- Subject** ▶ Change of Switch
- For Models** ▶ HP1200, HP1500, HP1501, HP2030, HP2031, HP2032, HP2033, 6307, 6407, 6408, 6410, 6807, 6821
- Country** ▶ All countries
- Description** ▶ As illustrated below, for further improvement in the durability of Switch;
 - (1) Switch of all the models mentioned above has been changed.
But there is no change in wiring and installing procedure.
 - (2) Handle or Housing of the following models has been modified at the same time;
HP2030, HP2031, HP2032, HP2033, 6307, 6407, 6408, 6821

(1) Change of Switch

(2) Modification of Handle or Housing

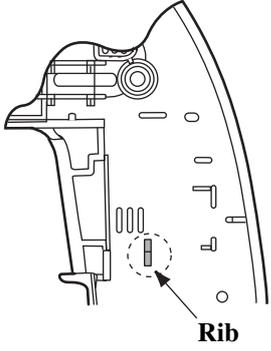
As illustrated below, the rib encircled by a broken line has been shortened in height.
When installing the new Switch on the current Handle or Housing,
be sure to cut the rib by 7 to 8mm.

▶ Current	▶ New
<p>(Left half)</p>	<p>(Rib)</p>	
For HP2030, HP2031 HP2032, HP2033	Handle Set (Part No.182724-1)	Part no. remains unchanged.
For 63047, 6407, 6408	Housing Set (Part No.182862-9)	Part no. remains unchanged.
